PLANNING AND DEVELOPMENT SERVICES STAFF REPORT

**SUBJECT: Staybridge Suites & Retail Rezoning and Planned Project Site Plan
File Nos. SP14-057 & Z14-028**

PLANNING AND DEVELOPMENT SERVICES STAFF REPORT

**SUBJECT: Staybridge Suites & Retail Rezoning and Planned Project Site Plan
File Nos. SP14-057 & Z14-028**

SHEET TITLE: **SITE LAYOUT AND PAVING PLAN**

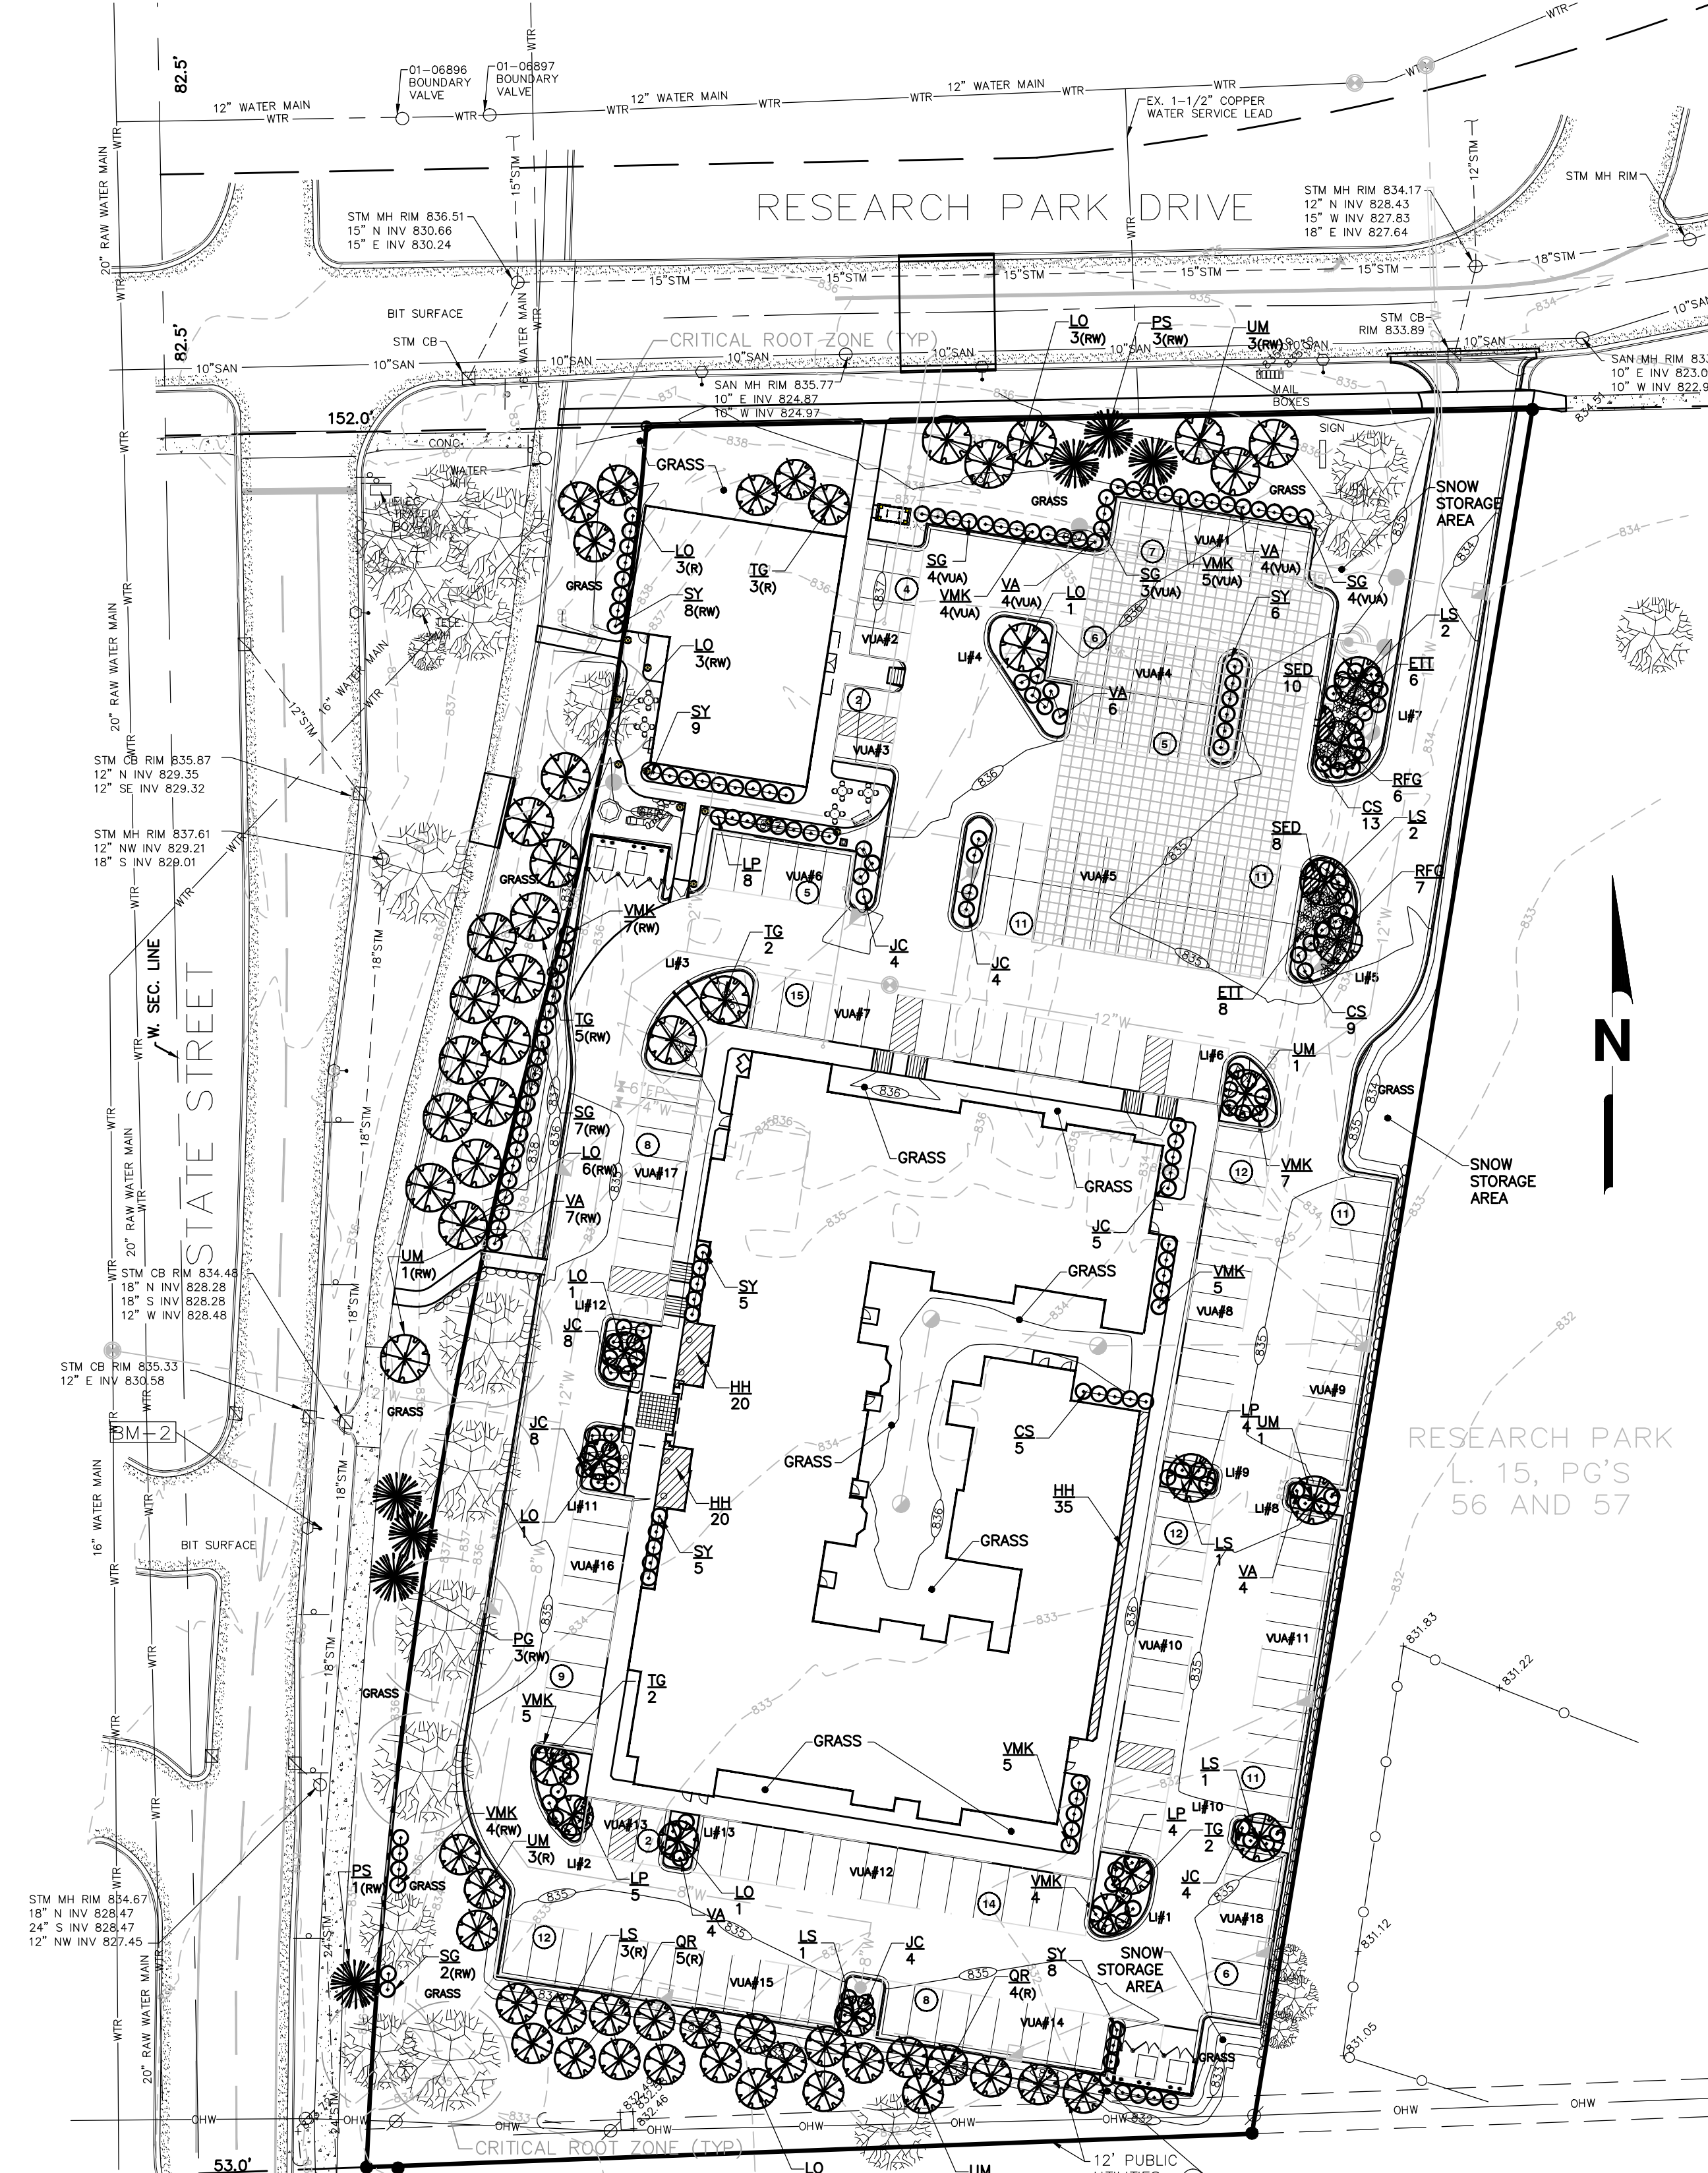
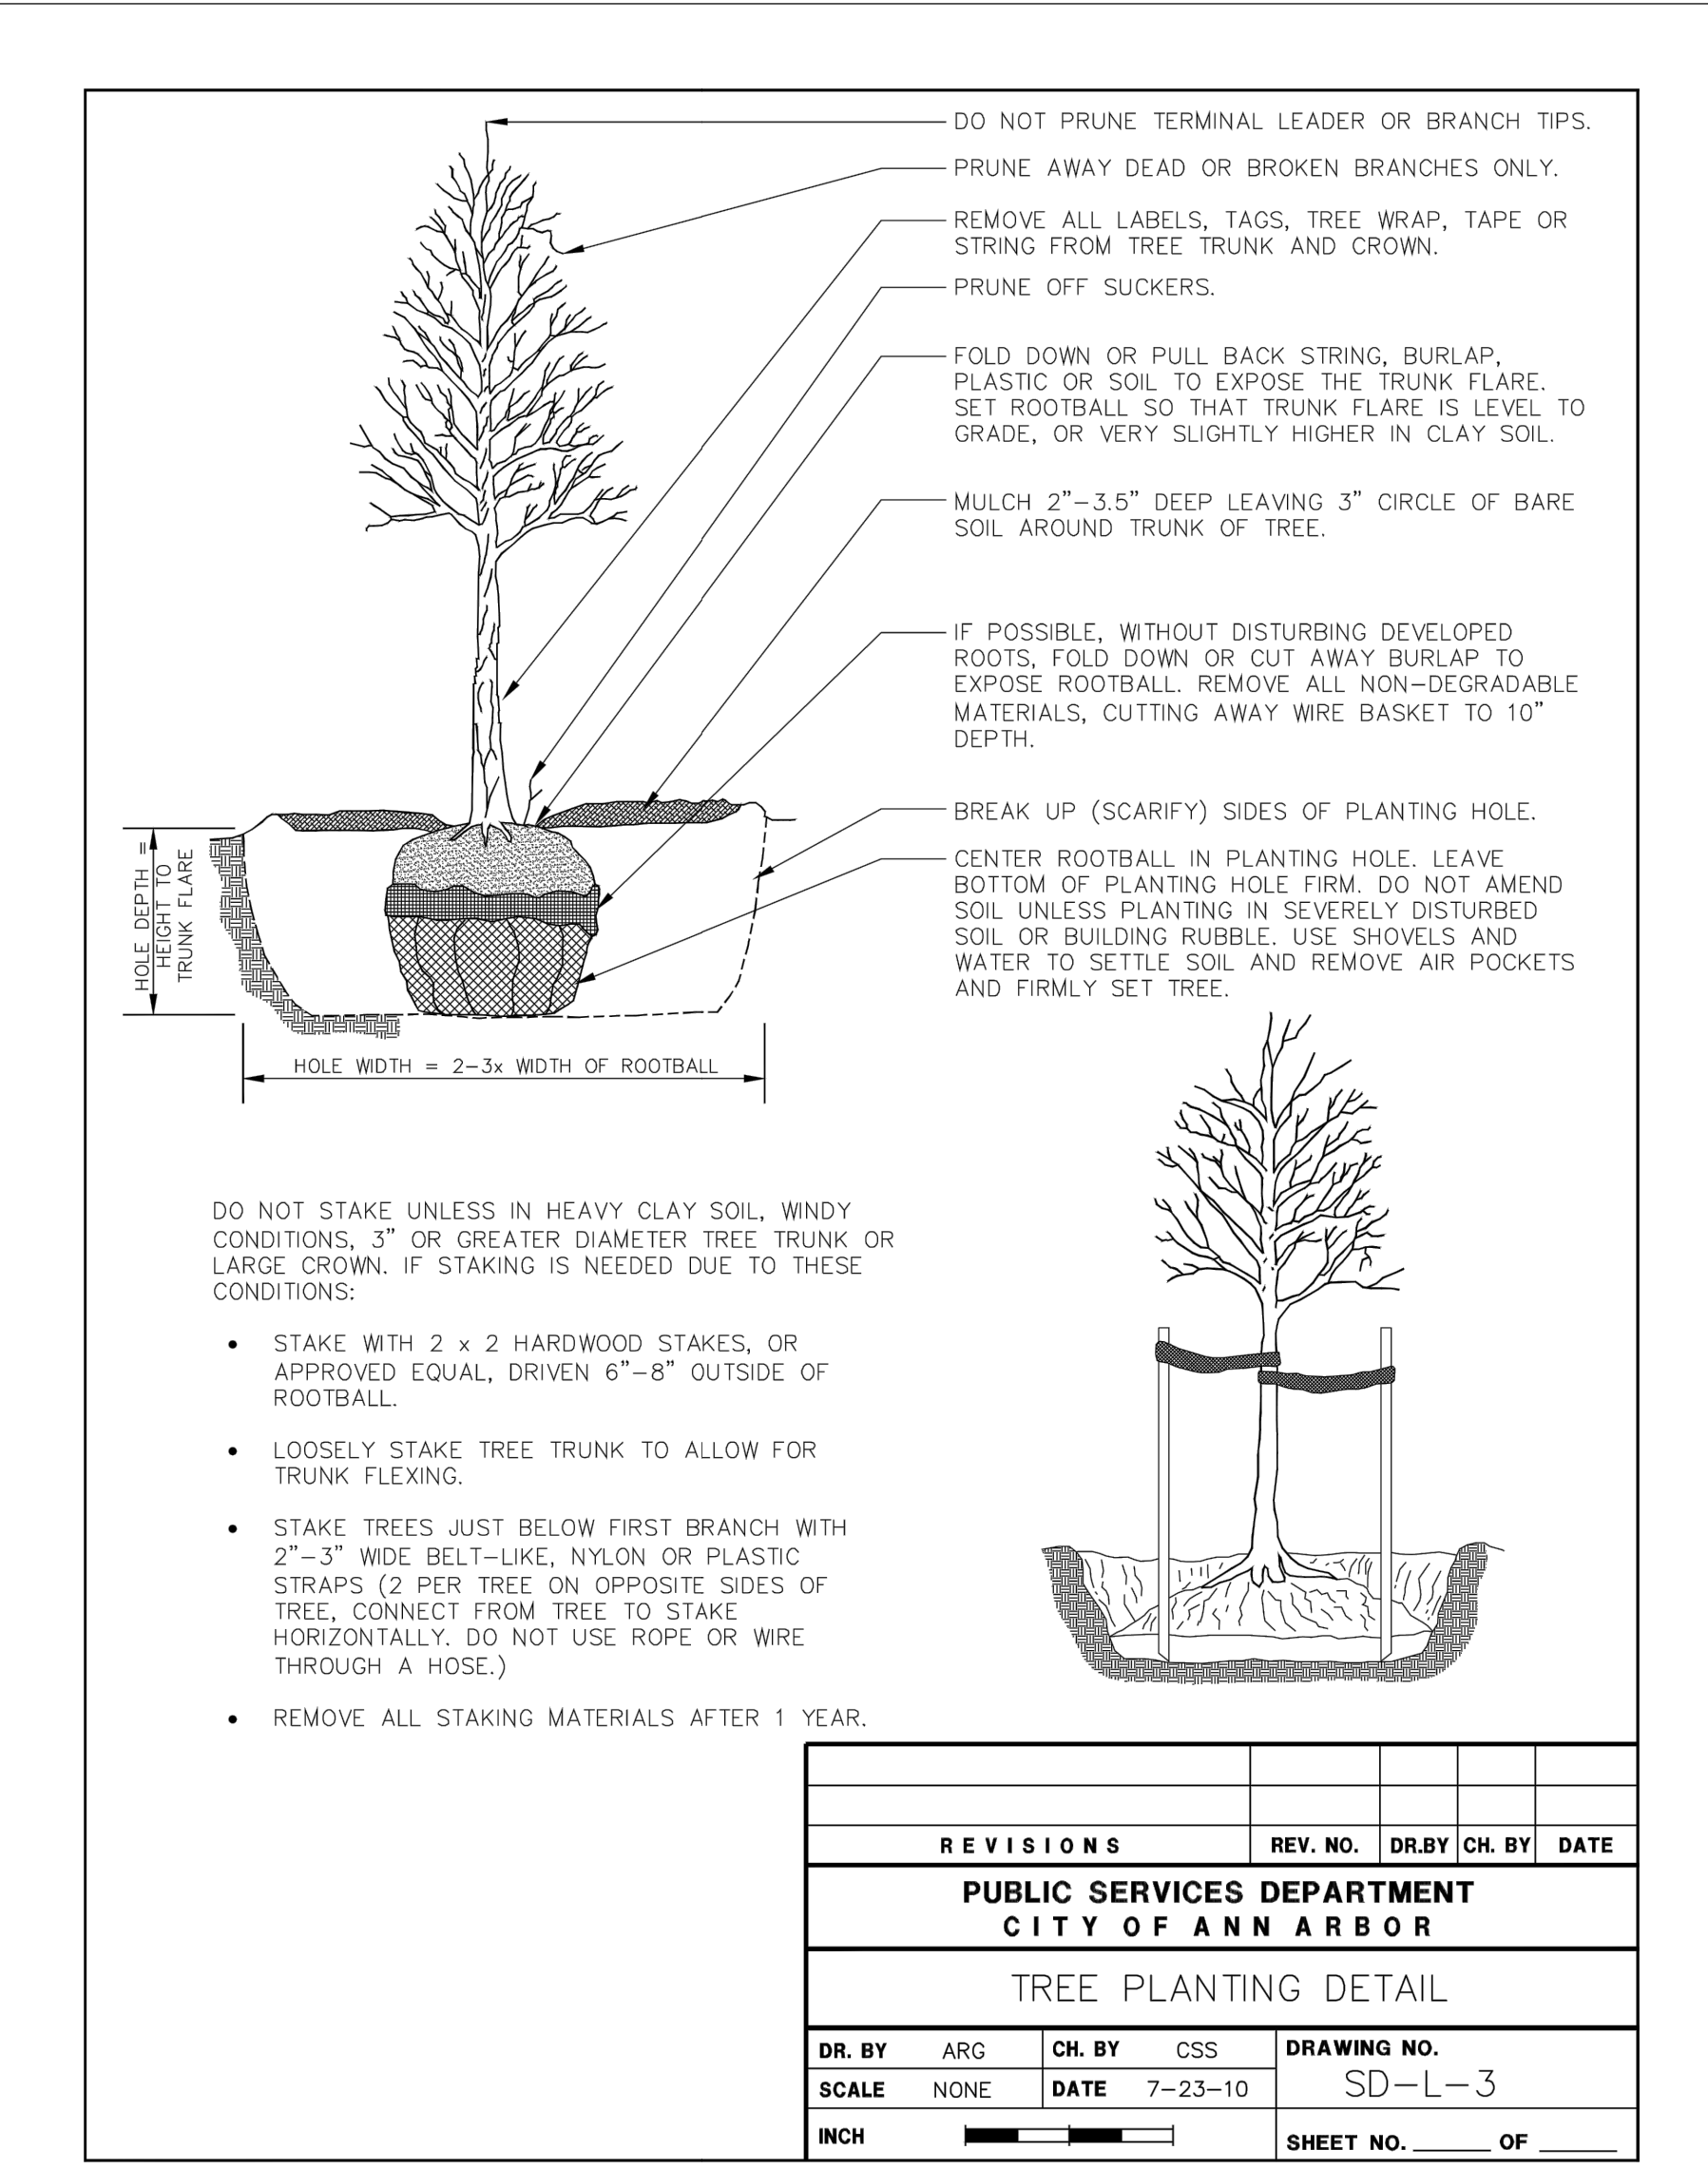
The previously submitted site plan layout showed encroachment of a parking aisle into the critical root zone of five landmark trees along the west side of this site.

To reduce impacts on the critical root zones of the landmark trees, the revised site layout reduced the drives on both the east and west side of the hotel from 24-feet to 22-feet and shifted the building and parking areas to the east. These changes shifted the western line of the proposed curb by approximately 4.25 feet east to be in the approximate location of the existing pavement. This shift does not require mitigation for the landmark trees.
